**DEVELOPMENT MANAGEMENT COMMITTEE**

**ADDENDUM SHEET**

**21/03089/MFA Construction of 46 dwellings (apartment building and two rows of terraced units), new access road, parking and amenity areas.**

**21/01058/FUL      Conversion of the existing water tower (sui generis) to residential (C3), incorporating the infilling of the concrete pillars at the base of the tower and the construction of a flat roof canopy; and the construction of new access road.**

*With regard to the revised information dated 1 December 2021 this appears to be a re-issue of the construction management plan drawing.*

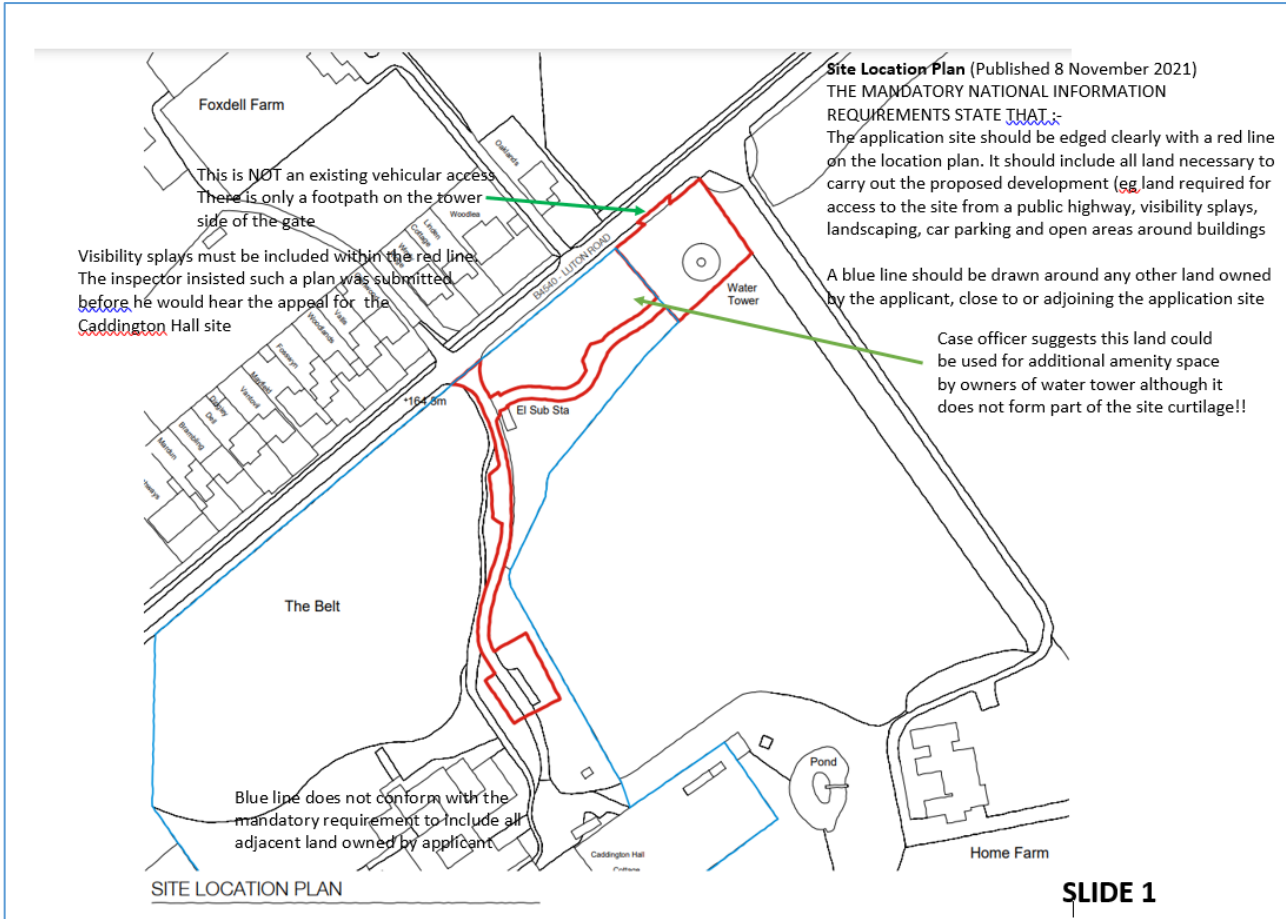
*The red and blue lines have been added (still incorrectly/incompletely) to this drawing.*

*It is disturbing that the report produced by RWA Consulting (which accompanied the original construction management plan) is now a superceded document.*

*Thus important information regarding matters such as building operations such as craneage (a very important issue as work will be taking place under the canopy of protected trees), waste management, ecology is now lacking.*

**MARKED UP ELEVATIONS SHOWING BUILDING AT NIGHT**

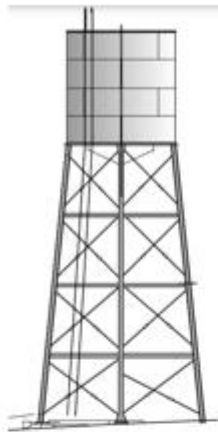
St Gobain Glass have confirmed to me that the glass specified will have NO light reduction properties, especially at night.

#### WATER TOWER AT DEVEY WAY, GOLDING EXTATE, WATERFORD

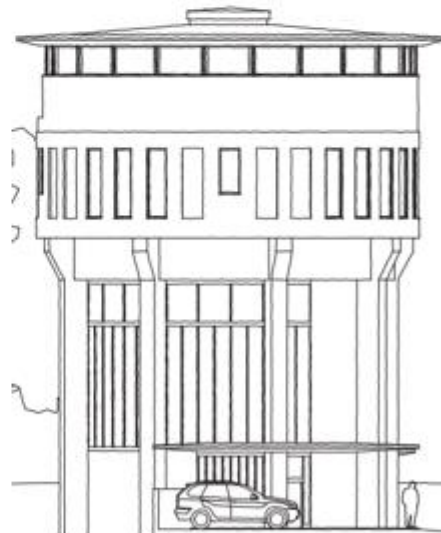
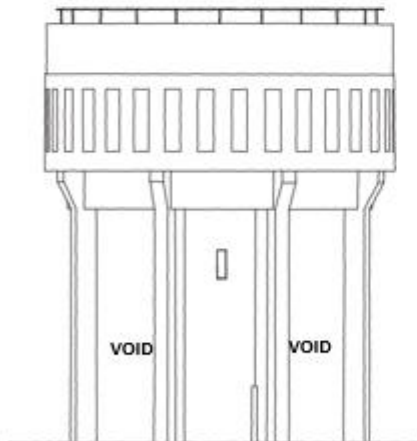
*'Its complete enclosure and extension clearly impacts on openness simply as a matter of fact'*

*'By infilling the sides of the structure beneath the water tank, the tower would have the appearance of a tall, 4-sided building as views through the supporting legs would no longer be possible. This means it would erode rather than preserve the openness of the Green Belt that is currently enjoyed in the vicinity of the structure'.*

#### WATER TOWER, LUTON ROAD

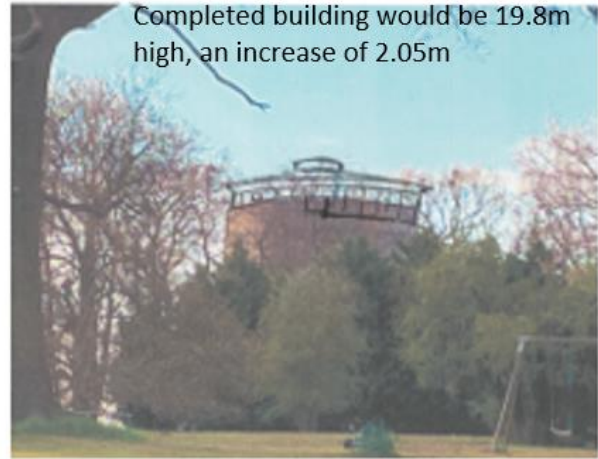
- The proposals involved 'substantial new building work'.
- The 'dramatic increase' in the bulk and height of the proposed building'.
- That the proposed development would 'significantly harm the openness of the Green Belt'.

**VIEWS FROM HOME FARM**

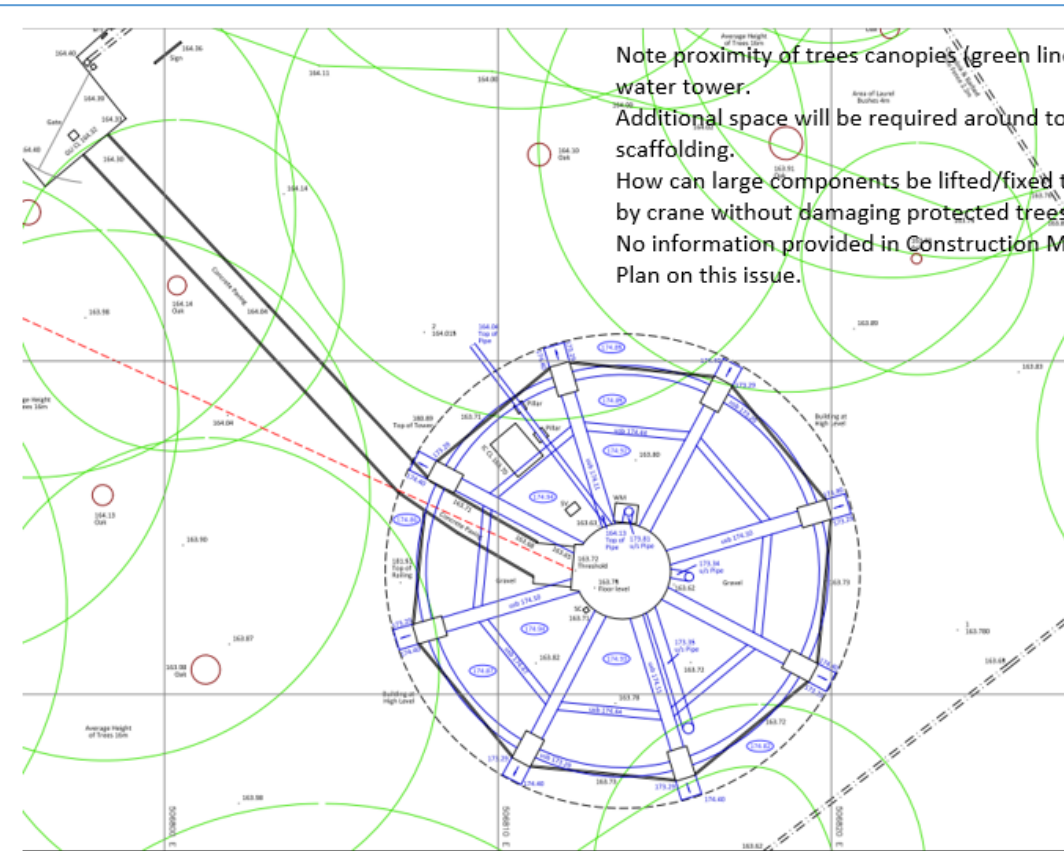
Completed building would be 19.8m high, an increase of 2.05m

**EXTRACT FROM SITE SURVEY DRAWING**

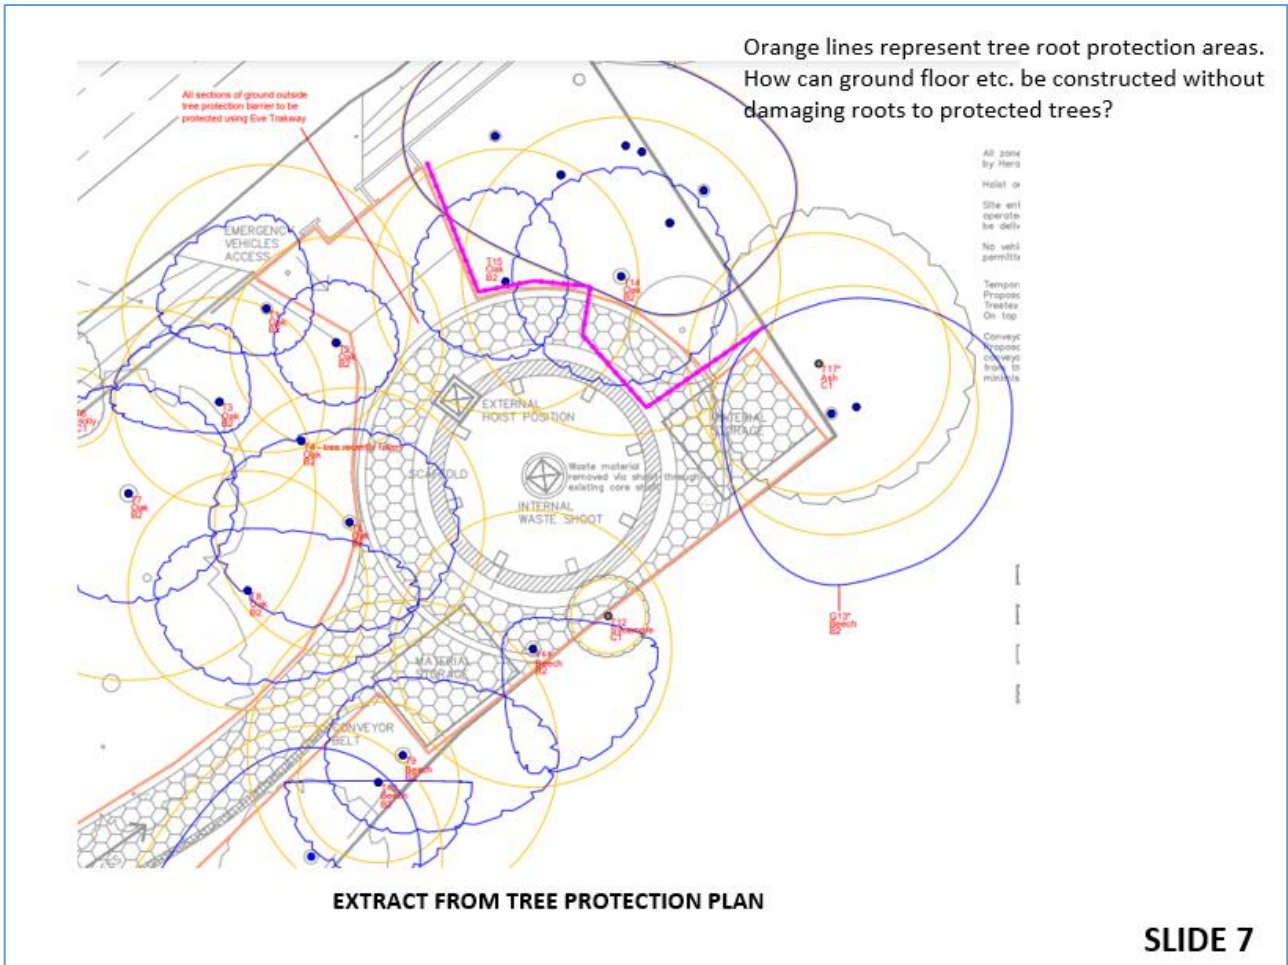
Note proximity of trees canopies (green lines) to existing water tower.  
 Additional space will be required around tower for scaffolding.  
 How can large components be lifted/fixd to side of tower by crane without damaging protected trees?  
 No information provided in Construction Management Plan on this issue.
